Used Oil Processing Facility Closing Cost Estimate Form

Facility Name: Cliff Berry Inc., Jacksonville Facility Permit Number: _____

AS-BUILT TANK LAYOUT PLAN

Responses to Attachment B of FDEP's comments on Cliff Berry Inc's July 18, 2012 submittal of DEP Form 62-710.901(7) entitled Used Oil Processing Facility Closing Cost Estimate Form.

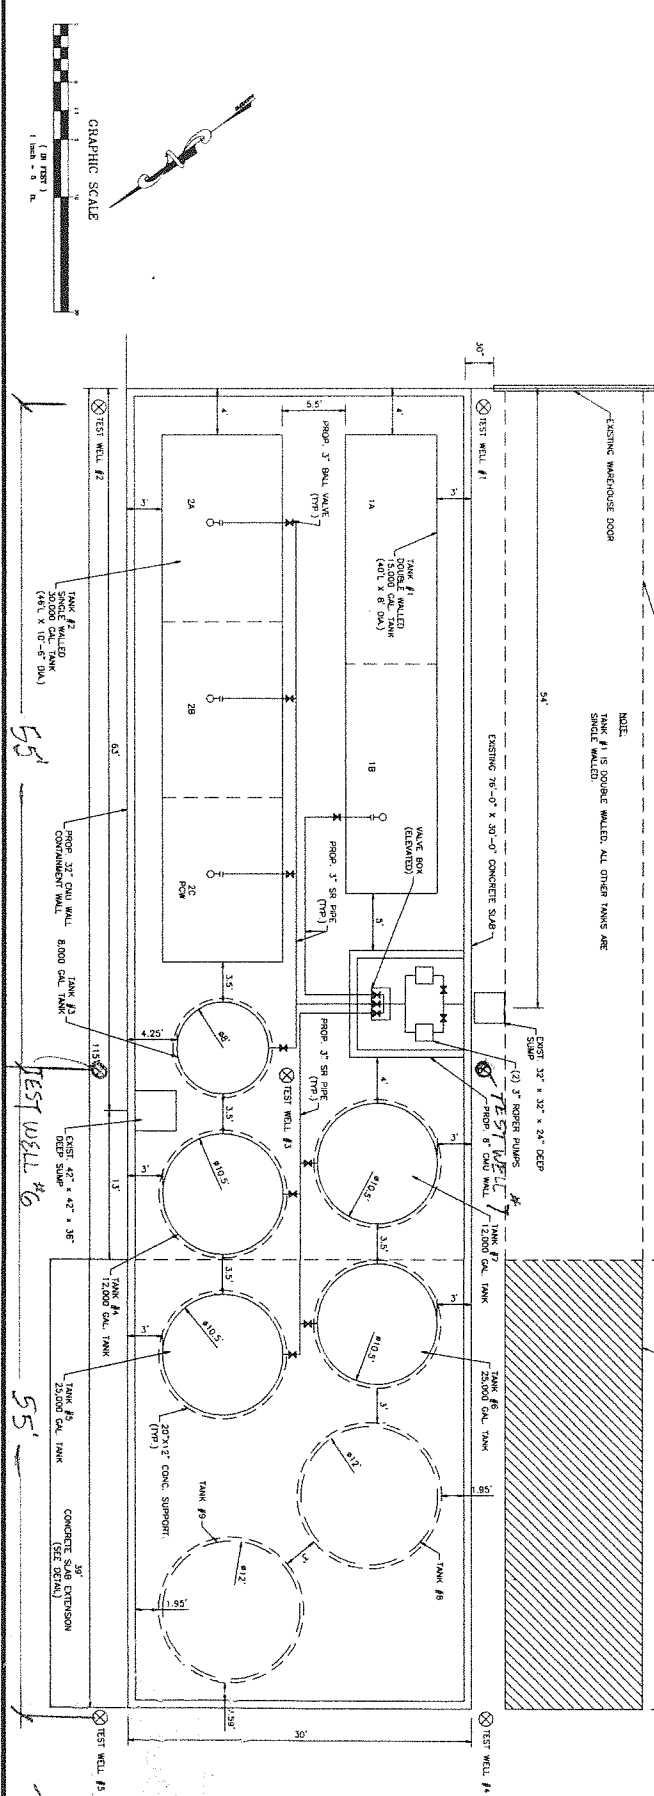
Statement: Page 3, Item 2.b: Please revise the cost of soil borings based on the below comments on closure plan. Also, include cost of sampling and analysis of soil and groundwater samples.

*Response: We have added three (3) additional soil borings for a total of seven (7) for the site. There are three (3) borings shown on both sides of the slab, 55' apart and one boring in the center of the slab. It is anticipated that the borings would be two inches (2") diameter and will extend to the water table which may be six (6) to nine (9) feet deep depending on the time of year. Soil and ground water tests will be made as required. The location of proposed test wells is shown on the site plan. In our view it is not necessary to have additional borings within the slab because it is unlikely to have an oil spill penetrate a twelve inch concrete slab.
